## **ISO TC 187 WG 4 - prEN ISO 8100-1 ed2 final draft with track changes**

**prEN ISO 8100-1 ed2 final draft with track changes 2023-09-05**

ISO/PRF 8100-1:2023(E)

Lifts for the transport of persons and goods — Part 1: Safety rules for the construction and installation of passenger and goods passenger lifts  
~~Passenger and goods passenger lifts~~

**Figure 1 — Partially enclosed well**

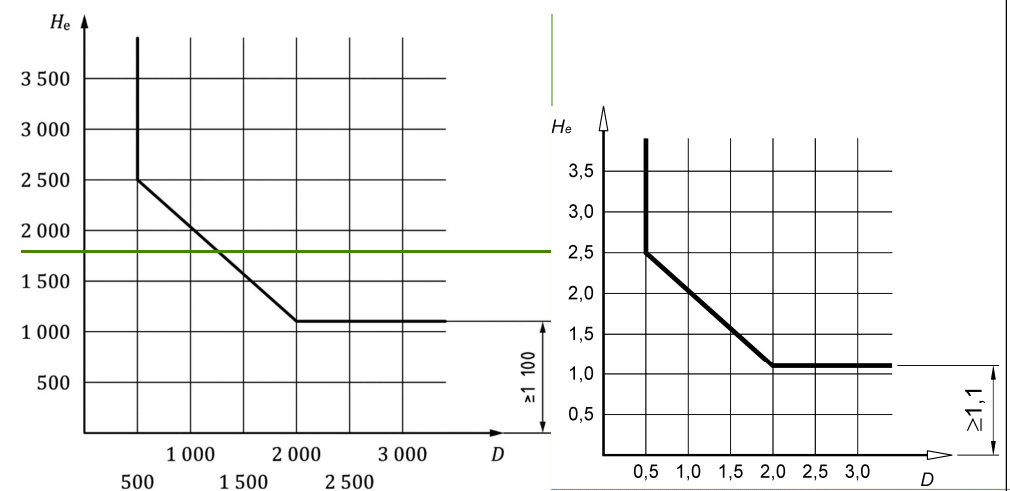
Commented [SD249]: Updated figure 1 with units in meters as per WG1 comments N1954

Figure 3 — Clearances between car and wall facing the car entrance

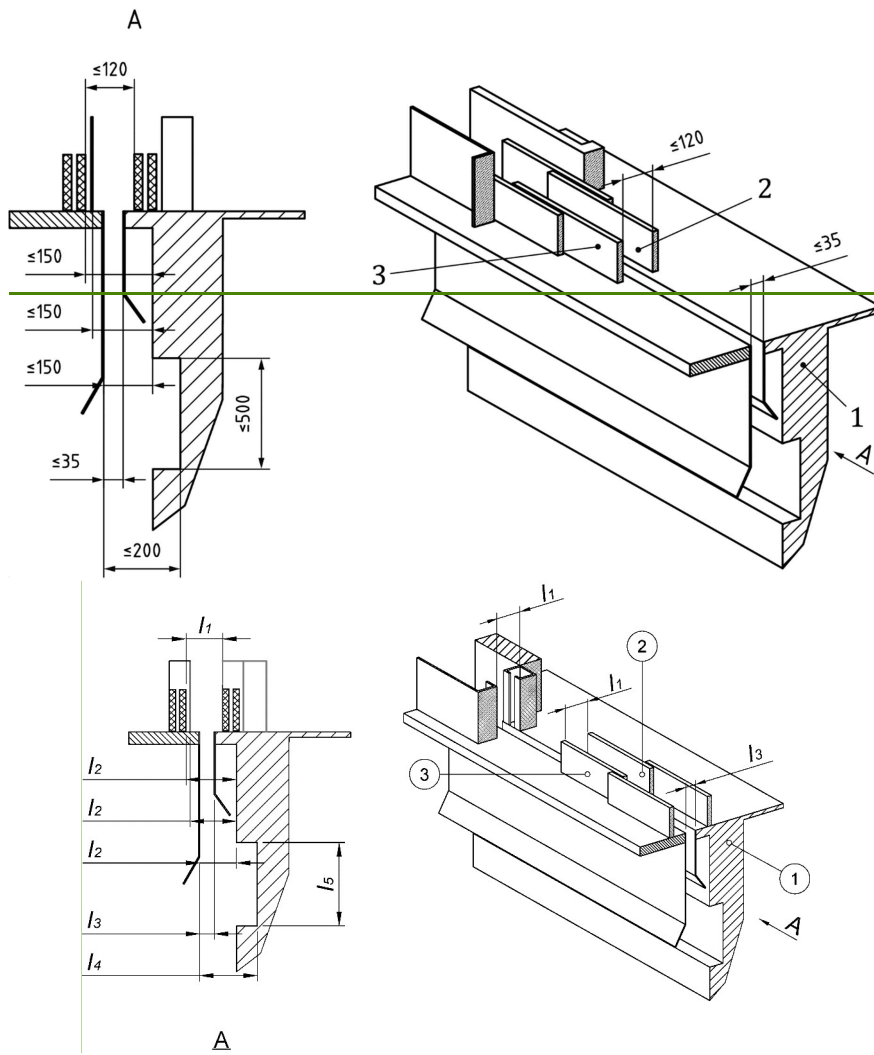
Commented [SD250]: Updated figure 2 with units in meters as per WG1 comments N1954

Commented [SD258]: New Figure 3 WG1 comments N1954 (added 4 to key to identify the door frame of the car & inner car wall return to reflect right hand drawing)

Figure 8 — Hinged landing door and folding car door

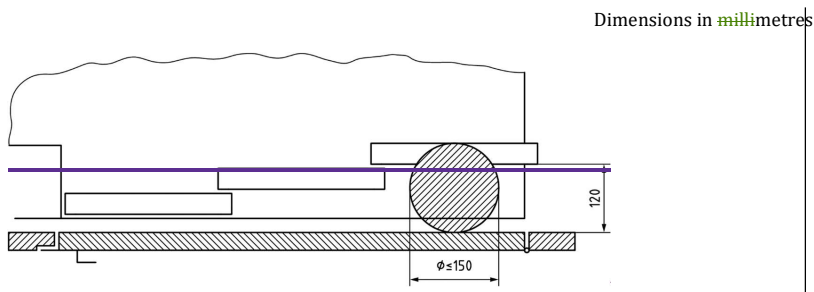
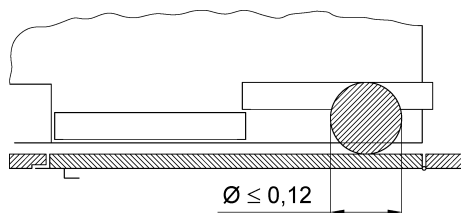
Commented [SD402]: Replaced Figure 8 as per WG1 comments N1950 now in meters

Figure 9 — Hinged landing door and horizontal sliding car door

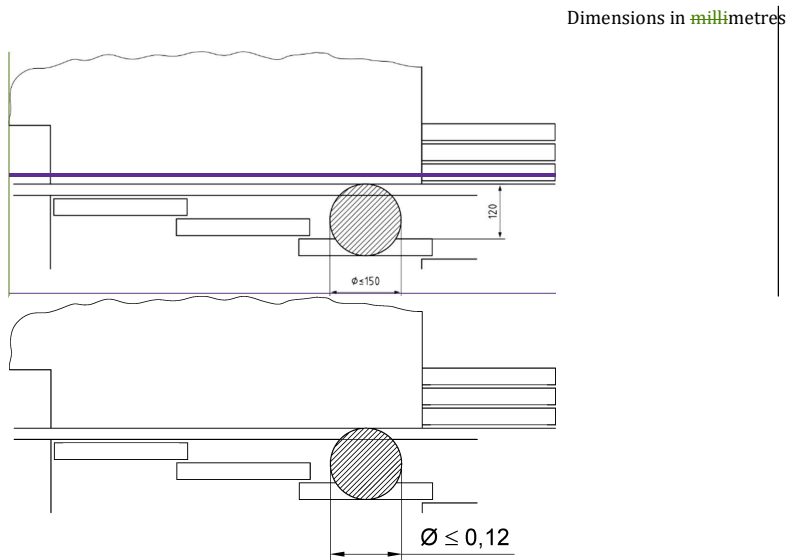
Commented [SD408]: Replaced Figure 9 with 9a as per WG1 comments N1950

Commented [SD409R408]: Updated Figure with clear line definition as per combined comments N2055

**Figure 14 — Horizontal door panels — Pendulum shock tests — Striking points**

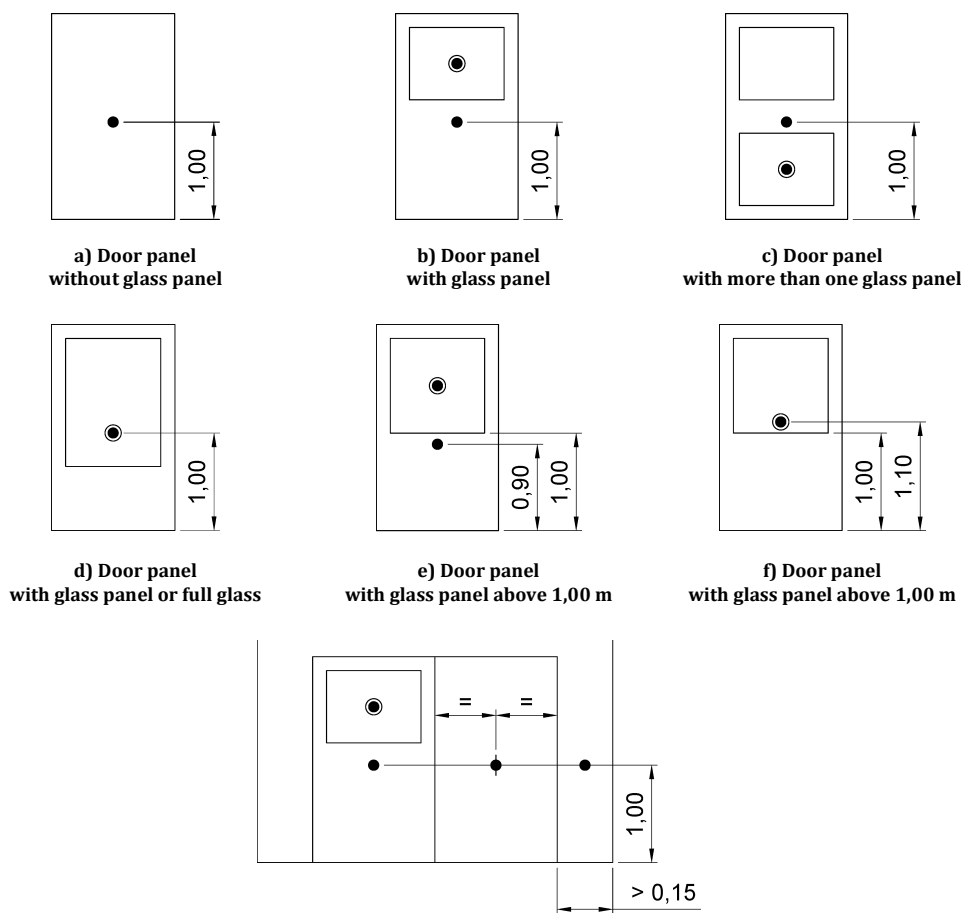
Commented [SD437]: AS per WG1 Comments N 1954

Commented [SD438]: Corrected Text, N2055 combined comments

Commented [AD439]: Text must be like for figure 14 e)

Figure 16 — Folding door recess

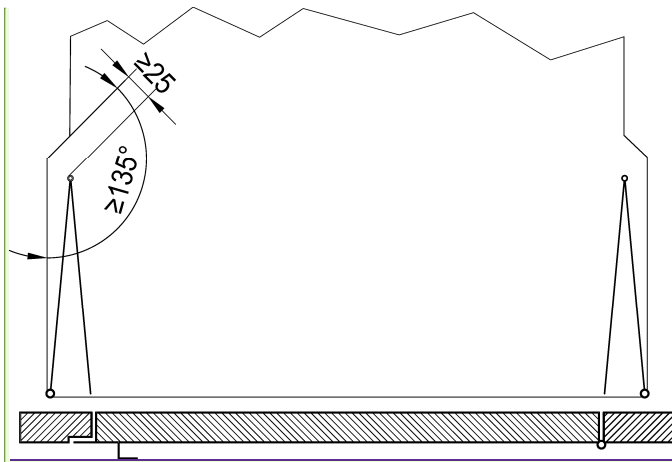
Commented [SD479]: Combined comments new figure N2055 (540)

Figure 15-25 — Example of components providing protection from falling (Electric lifts)

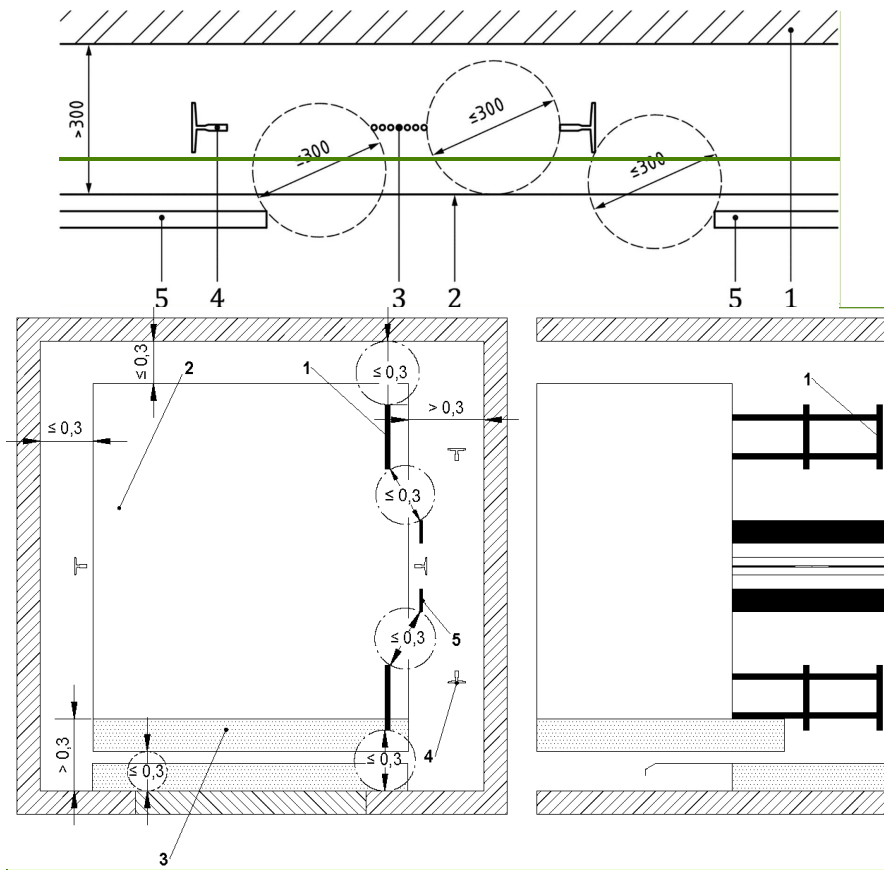
Commented [SD621]: New figure as N2017  
 Commented [SD622R621]: Amended Figure as combined comments N2055 (added 1 to identify balustrade on the left view)

Figure 16 23 — Example of components providing protection from falling (Hydraulic lifts)

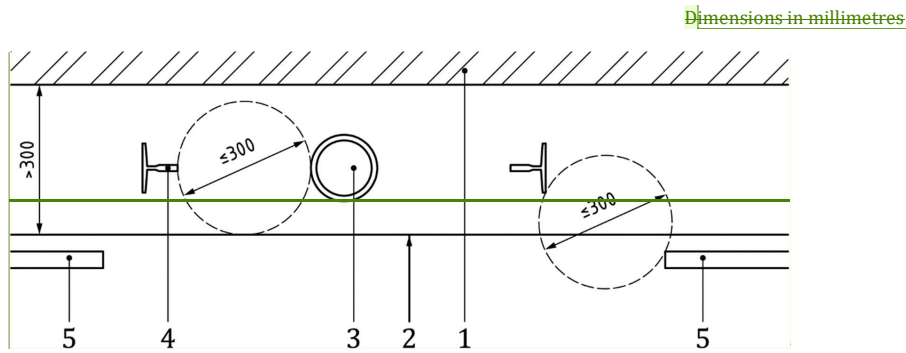
Commented [SD623]: Update Key for new figure as N2017

Commented [SD624]: WG1 Comments N2017

Figure 27 — Example for the number of full trips to be considered based on option a) or b).

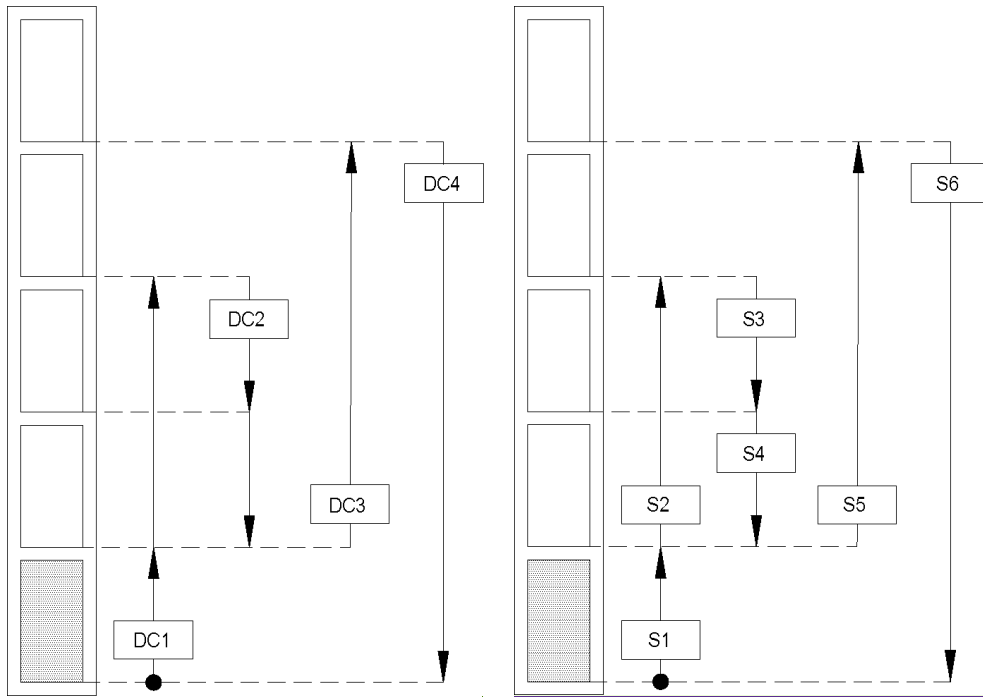
Commented [SD737]: Added reference to Figure 27a)

Commented [SD742]: Combined comments N2055 & N2193

Figure 28 — Examples of full trip bending sequences and the resulting number of simple bends  $n_{SB}$  and reverse bends  $n_{RB}$  to be considered for the most stressed suspension means section

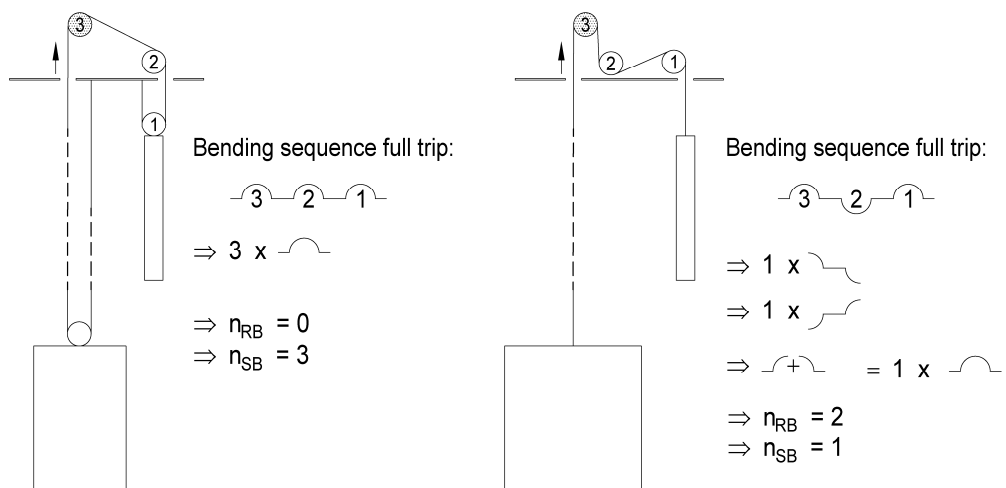
Commented [SD748]: As WG1 comments (& N2010)

**Figure F.1C.1 — Handling force for movement of ladder**

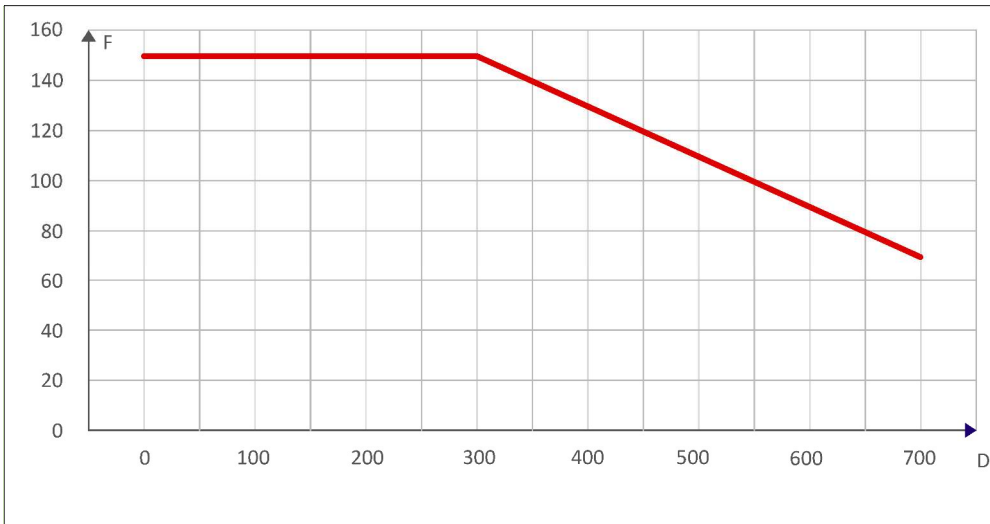
Commented [SD1526]: Combined comments N2055 and N2163

Commented [SD1527]: Combined comments N2055 and N2163

Commented [SD1528]: Combined comments N2055 and N2163

Figure F.1 3C.3 — Types of pit access ladder

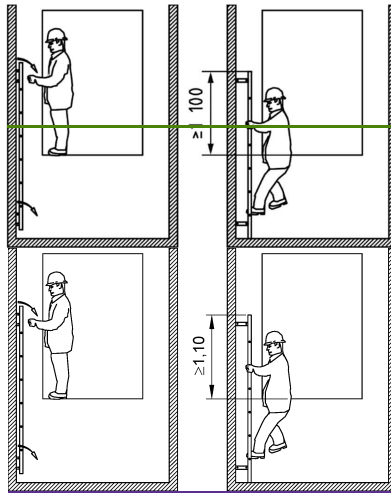
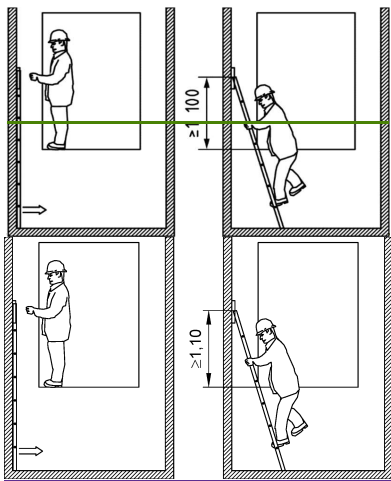
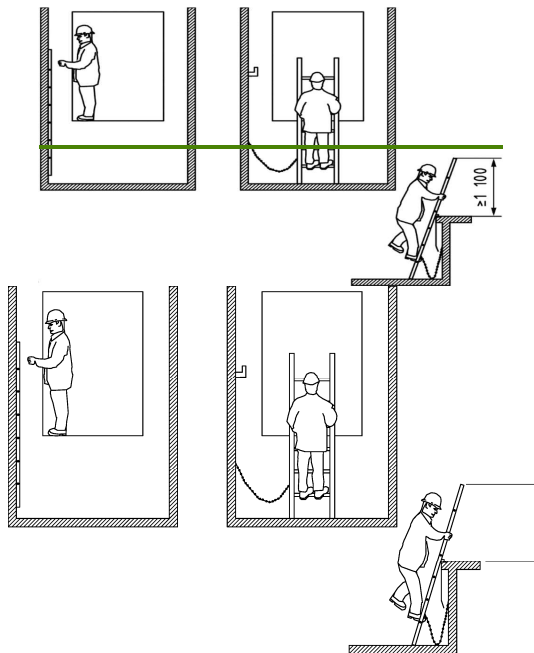
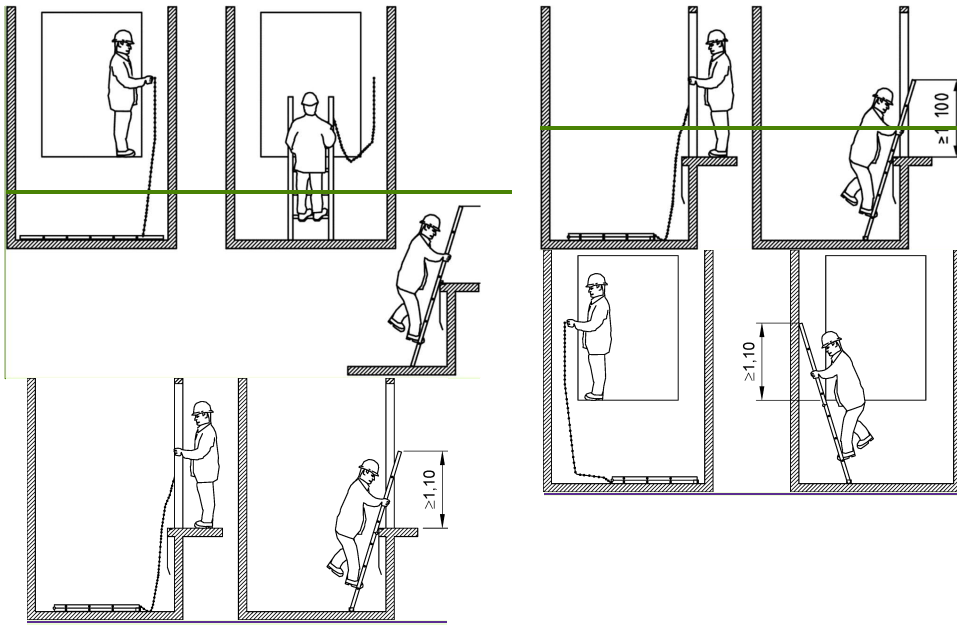
Commented [SD1542]: Updated figures to from  $\geq 1.100$  to  $\geq 1,10$  to align with F.2.3

Commented [SD1544]: Updated figures to from  $\geq 1.100$  to  $\geq 1,10$  to align with F.2.3
